## Model Error Resolution Document

1. Originator: Alicia Aragon	2. Date: 04/01/08	3. ERD No.: MDL-NBS-HS-000023 ERD 01
------------------------------	-------------------	--------------------------------------

4. Document Identifier: MDL-NBS-HS-000023 REV 01 <b>AD 01</b>	5. Document Title: Simulation of Net Infiltration for Present-Day and Potential Future Climates
---	---

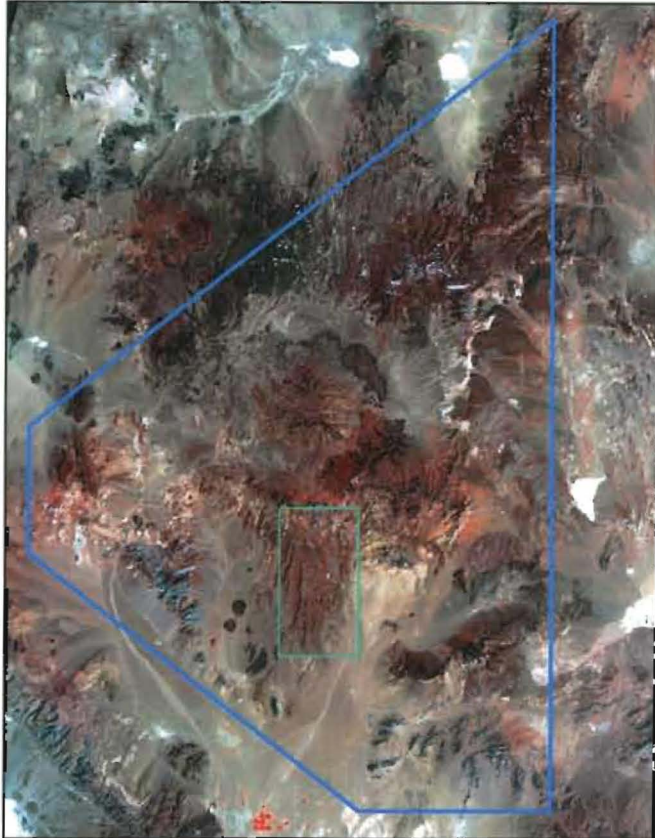
This ERD addresses CR 11824 which identifies an error in Figure E-7 of the model report *Simulation of Net Infiltration for Present-Day and Potential Future Climates* (MDL-NBS-HS-000023 REV 01 [DIRS 174294]).

*"Figure E-7 in MDL-NBS-HS-000023 REV 01 shows satellite image of the Yucca Mountain region with the infiltration modeling boundary and the boundary of the region used for Dark Object Subtraction (DOS) atmospheric correction. The figure is from output DTN SN0608NDVIANAL.001, file: "B3\_B4\_DOS\_ROI\_2.xls". The error is that the figure in the report is displayed as a mirror image. In other words, the left side of the figure is the eastern side of region and the right side of the image is in the western side of the region. The figure in the output DTN is displayed correctly. This error is only in the graphical representation of Figure E-7. The analysis results are not affected."*

To resolve this issue, Figure E-7 on page E-21 is to be replaced with a correctly oriented image from output DTN: SN0608NDVIANAL.001, file: "B3\_B4\_DOS\_ROI\_2.xls" as shown below. The caption and sources listed for Figure E-7 are to remain unchanged.
